PLANNING APPLICATION RESPONSE LETTER

PROJECT ADDRESS: 1609 and 1615 Grand Avenue
PLN RECORD #: PLN2024-00181
DATE: Friday January 10, 2025 – Review # 3
APPLICANT: Ben Eilenberg, GRAND SANTA BARBARA LLC
socialindustrialequities@gmail.com
ASSIGNED PLANNER: Barbara Burkhart, BBurkhart@SantaBarbaraCA.gov
STATUS: INCOMPLETE

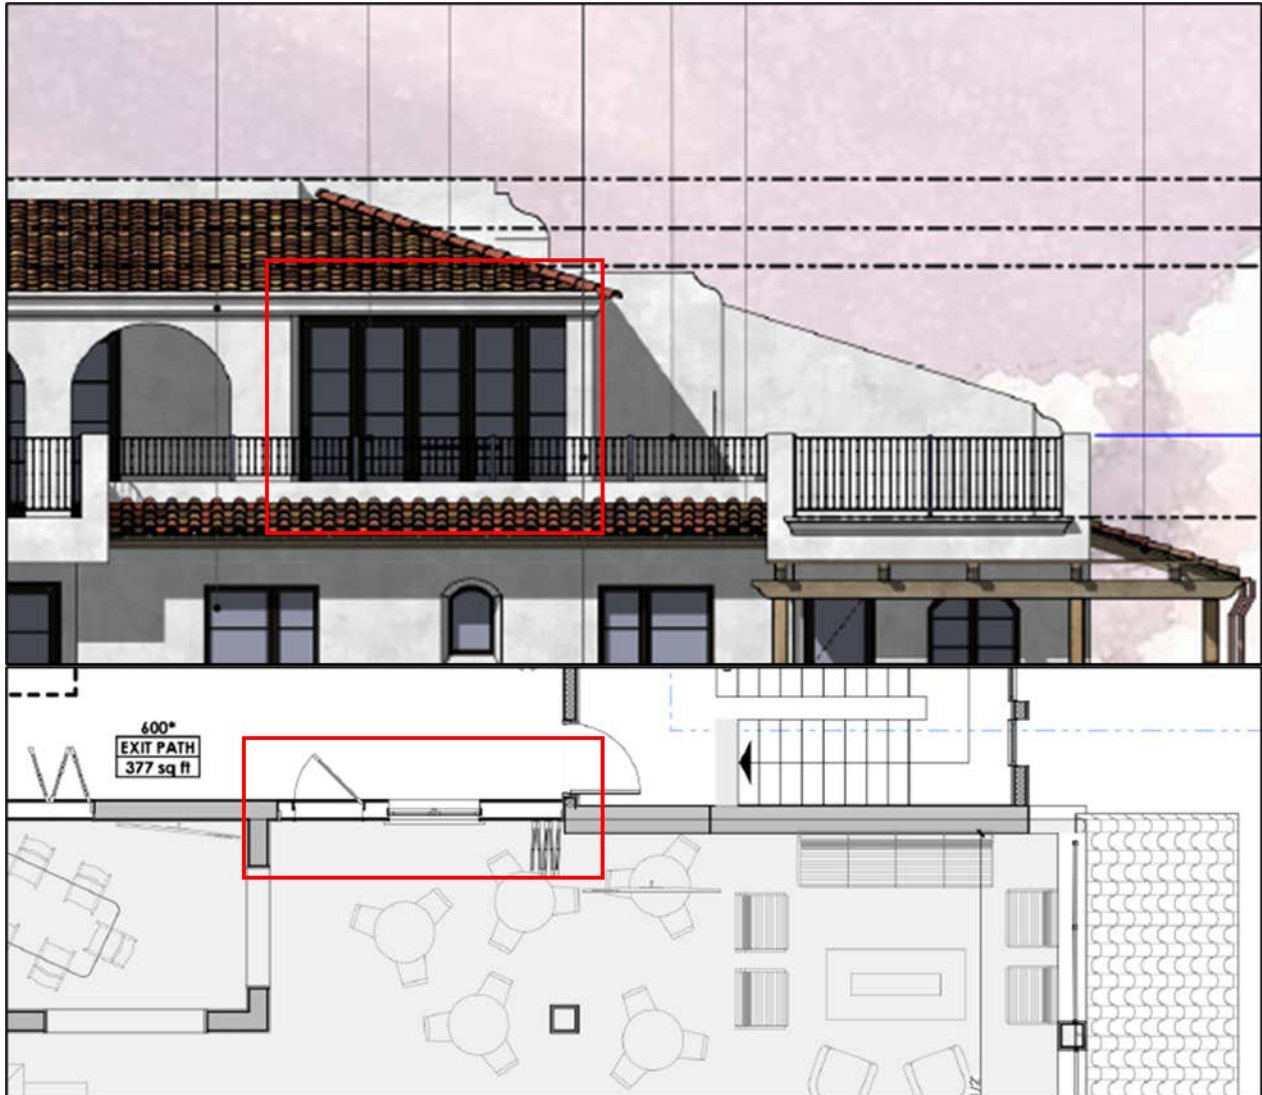
2. Site Plan. Include the following requirements, as identified in the Project Plan Submittal Guide, on the site plan:

- Label the distance from the structures to the property lines.
 - Please dimension the distance from the structure to the closest property line in all instances where the structure encroaches into any required setback.
- Common Open Yard
 - Thank you for providing square footage information for the Common Open Yard in the Residential Private Open Yard Calculations table. Please also call out these areas on the Site Plan.

Figure 1 SBMC Sec. 30.15.090.A

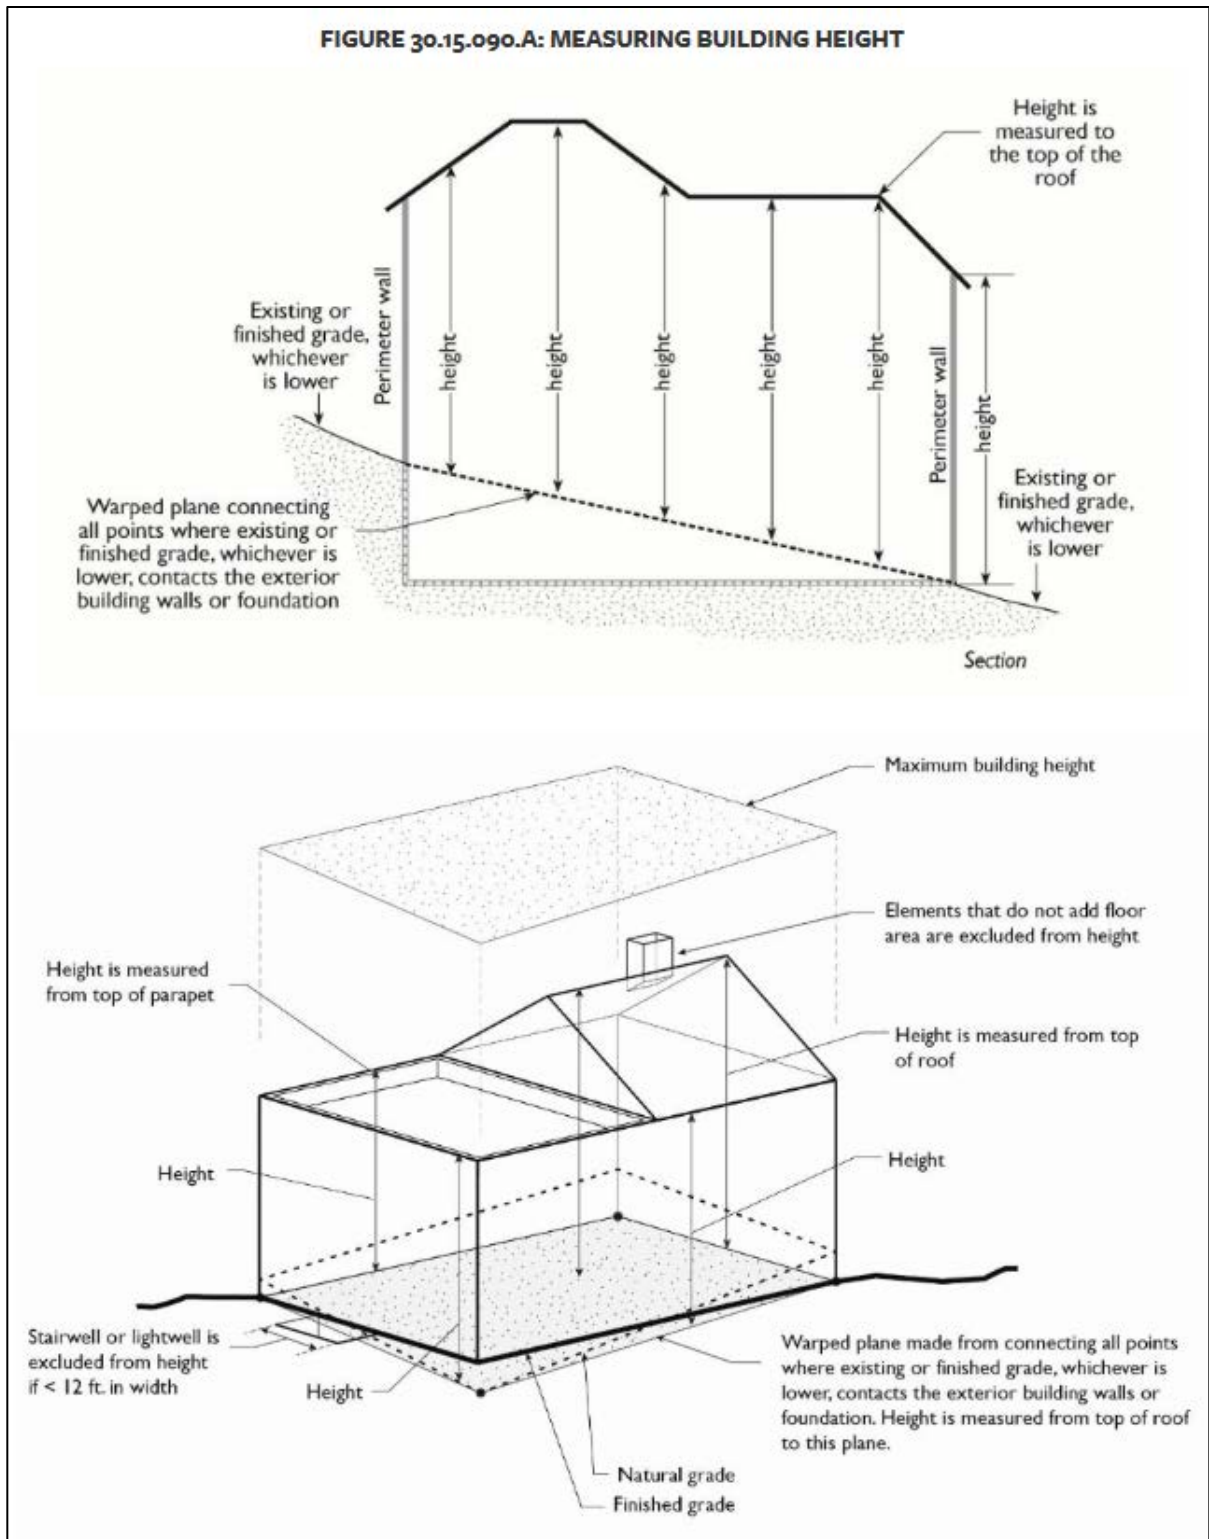
- b. Please also indicate the location of the 30-foot maximum building height for the R-2 zone.

Thank you for including a 30-foot maximum height line on the elevation drawings; however, it is shown incorrectly on the North Elevation. Please revise to measure from where existing or finished grade, whichever is lower, contacts the exterior building walls or foundation system at all relevant points.

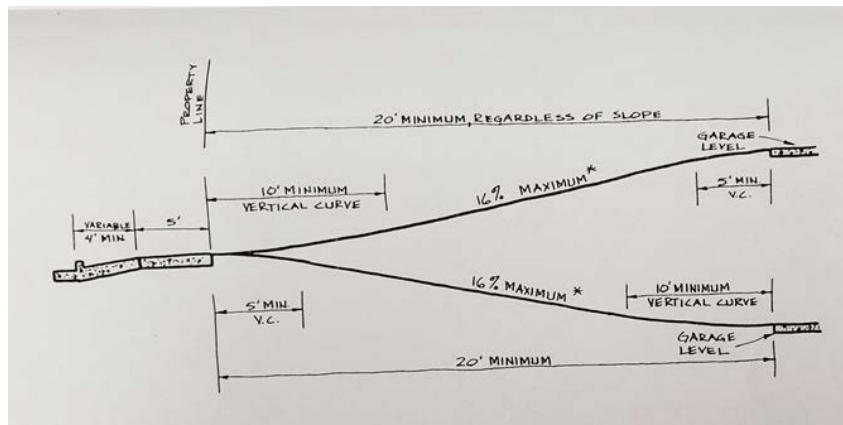
12. Loading. Demonstrate the proposed loading area can accommodate a 26'-0" and 20'-0" delivery/moving truck and 32'-0" Marborg trash truck. Clearly identify the path of travel for a 26'-0" and 20'-0" delivery/moving truck and 32'-0" Marborg trash truck. Demonstrate the delivery/moving trucks and trash truck can complete all the necessary turns through the path of travel via Autoturn. Additionally, demonstrate the

delivery/moving truck and trash truck can clear the garage opening. None of these vehicles are allowed to back up to the public right-of-way.
